Proposed Perth Petrol Station

Air Quality Assessment

Proposed convenience store - air quality advice for Town of Bassendean

ERM Air Quality Assessment - Peer Review

Figure 4.2: Modelled source locations

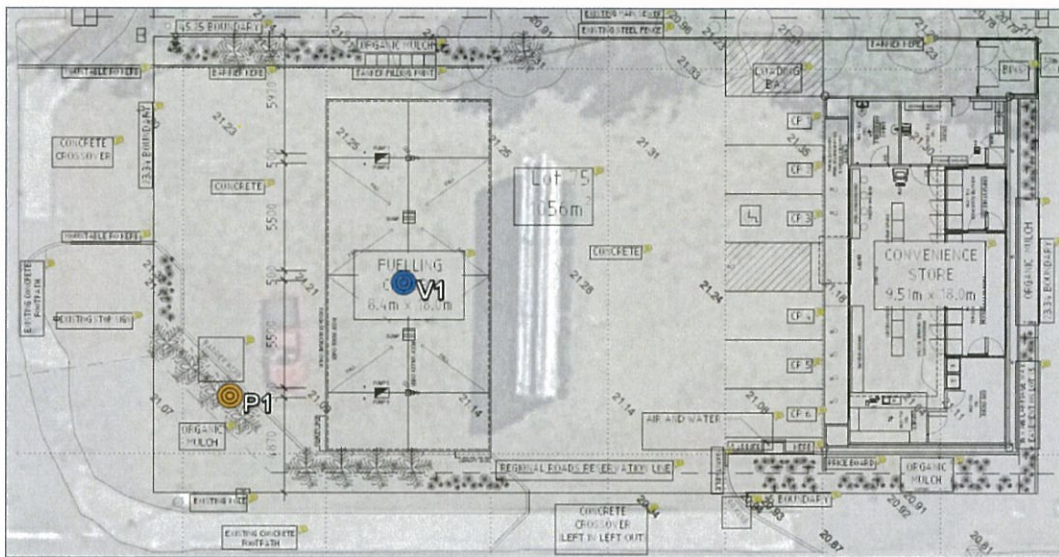
- The parametrisation of the emission sources is acceptable as per the recommended values from CAPCOA (1999). However, the point source (P1) is double the height (7m) of the common tank vent pole, i.e. 3.6m. Clarification of this source parameter by the proponent is required in the report.

- Building downwash was not considered by ERM. Our review of satellite imagery indicates that the distance from the proposed vent pipe to the nearest sensitive receptor is approximately 30m. Compared to modelled results without incorporating building downwash, CAPCOA advice that concentrations would increase by 5% at 20m from the vent pipe with building downwash. The concentrations with and without building wake effect are equal at approximately 50m.

Figure 5.1: Benzene annual average contour (criteria – $10 \mu\text{g}/\text{m}^3$)

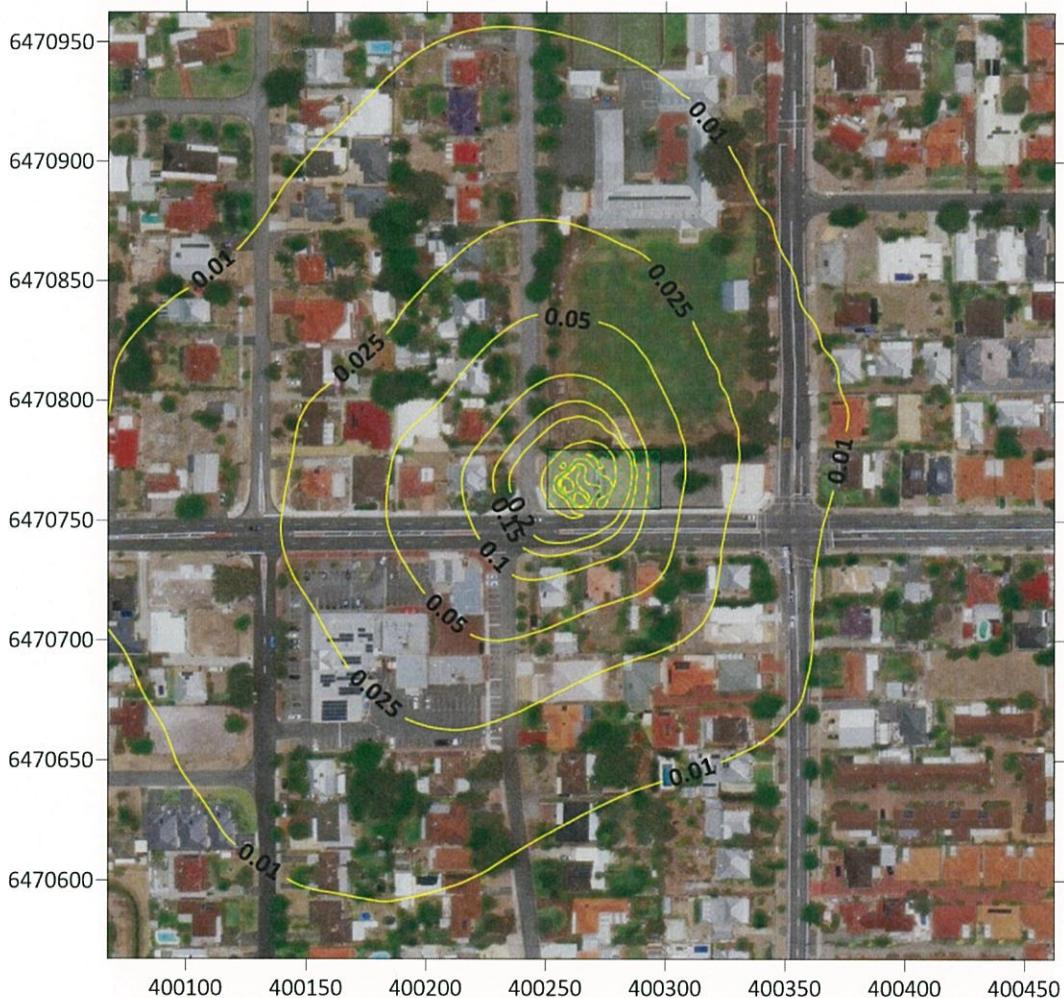
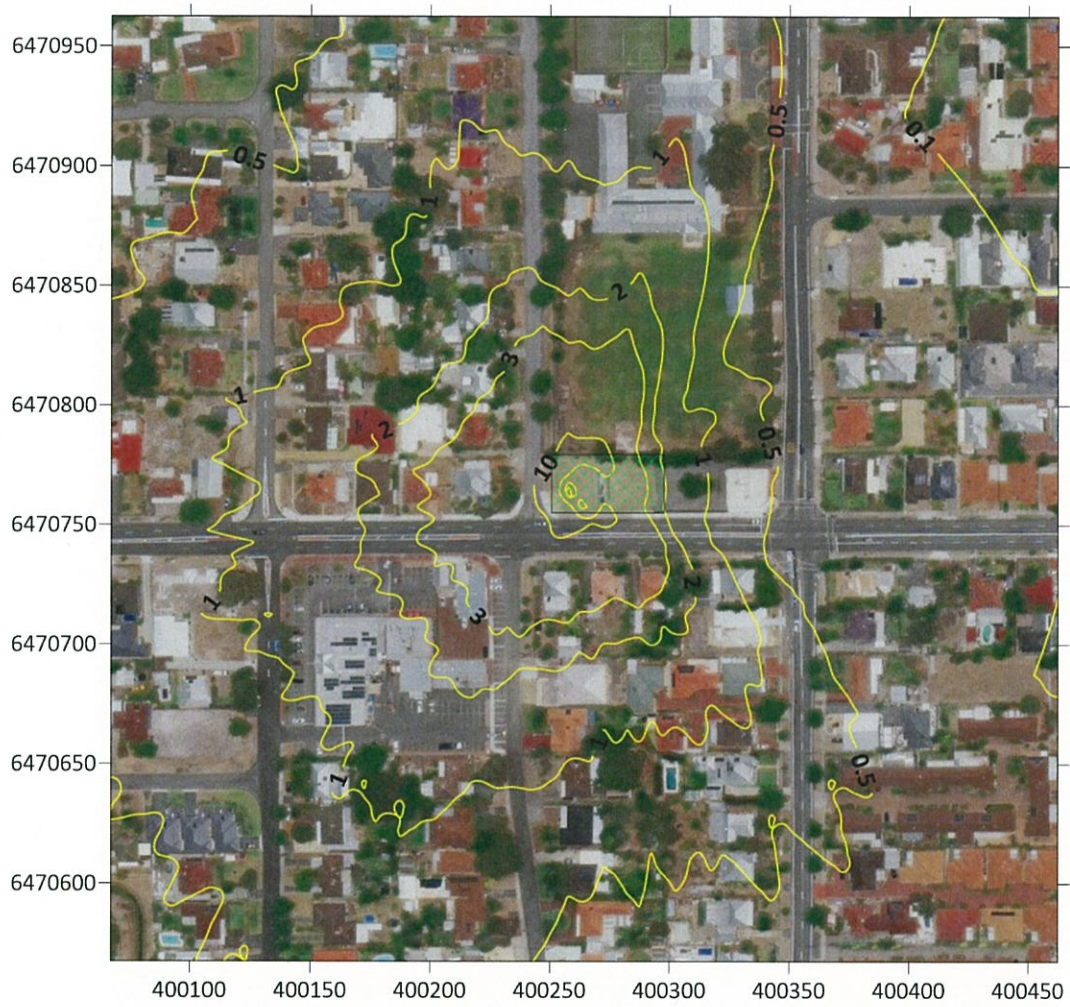
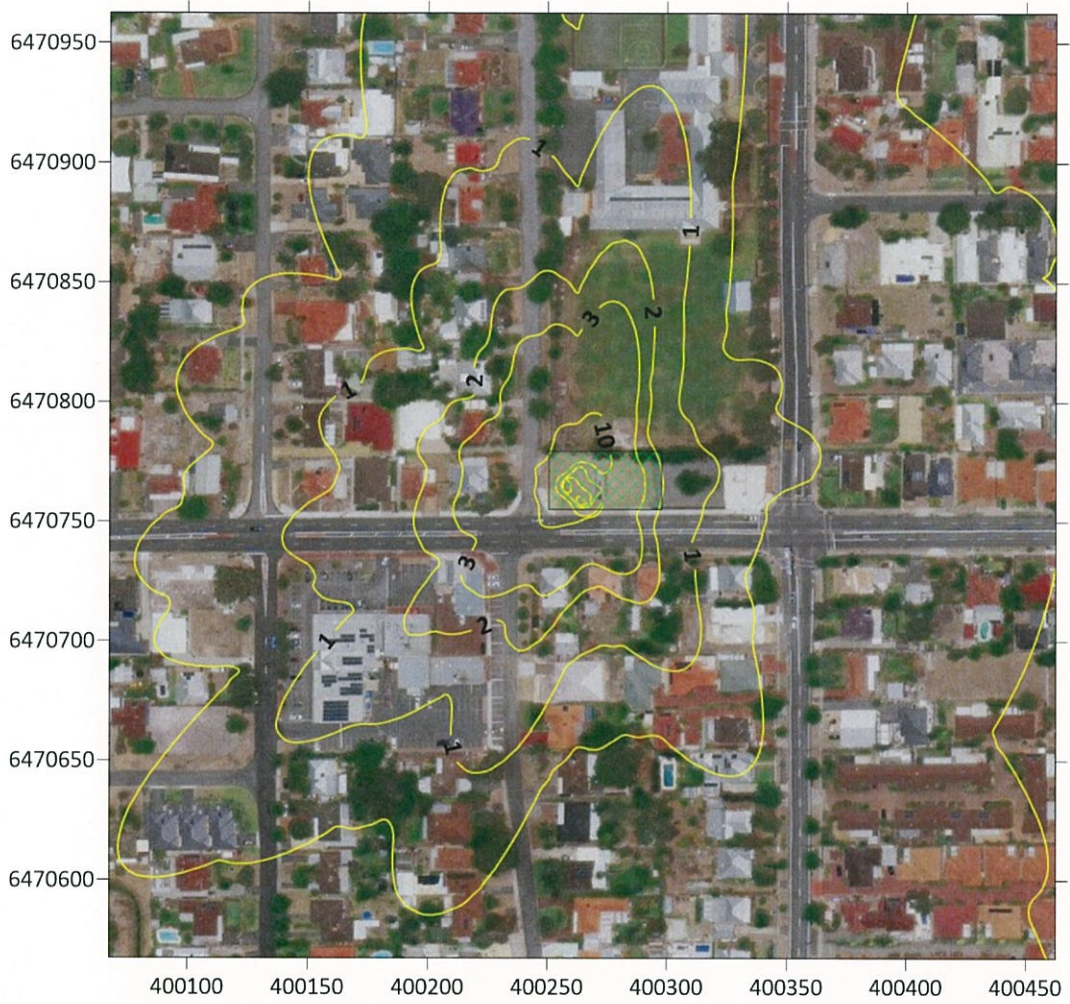
- The ERM report shows that modelled GLC contours are well below the assessment criteria.
- Only contour plots are presented. The modelled GLCs at sensitive receptors are not presented or discussed.
- Background concentrations are not discussed in the ERM report. The adopted criteria are designed for cumulative impacts (i.e. emissions from the proposal plus background concentrations).
